Service Technical Information

MODEL NO.	XR-MD90 EZ
SUBJECT	Noise at tuner function

REF.No. :G - 99 - 055 - E0

DATE :08. NOV . 1999

TUNER C.B PATTERN SIDE

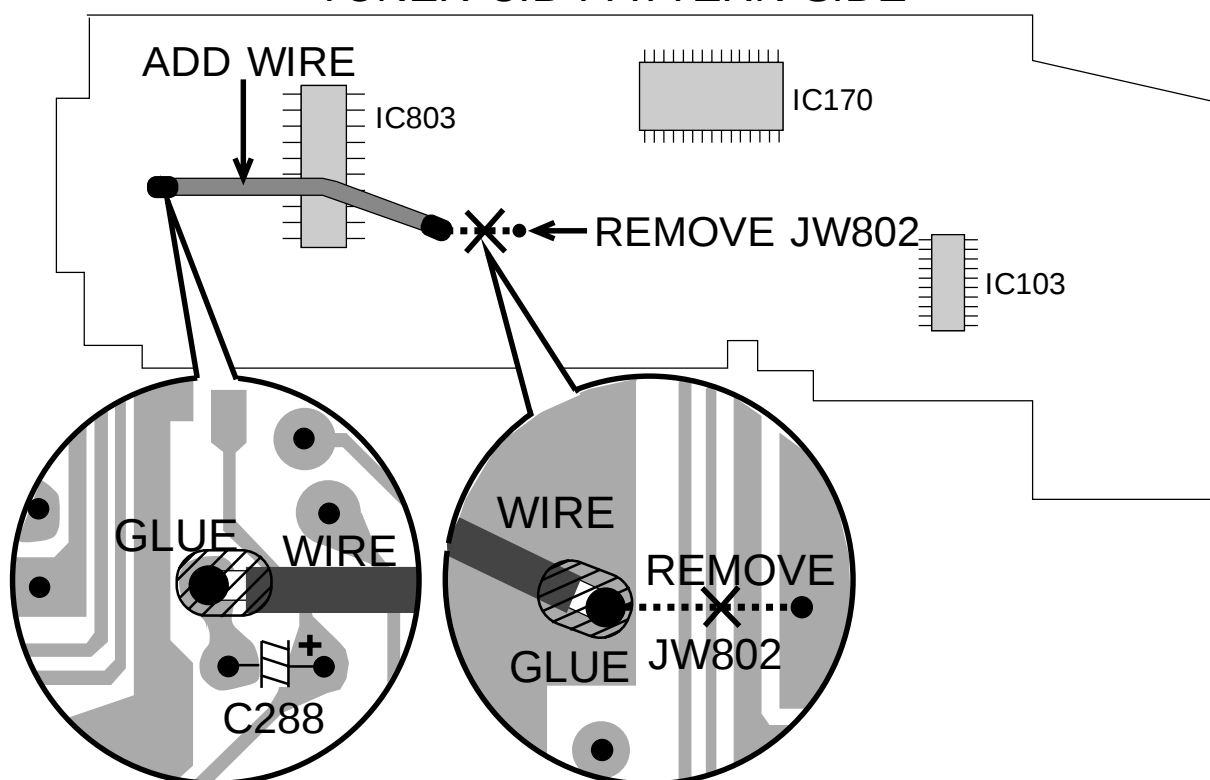
A high-frequency noise is heard with a volume at "0" position in the tuner function mode.
Take the following actions if the problem occurs.

1. Remove CABI, TOP AMP in the amplifier block.
2. Remove the JW802 tuner C.B..
3. Solder the wire onto a JW802 pin (one connected to pin 5 of IC803).
4. Solder the other side wire onto a digital ground (minus pin of C288).
5. Lock the both end of the wire with glue.
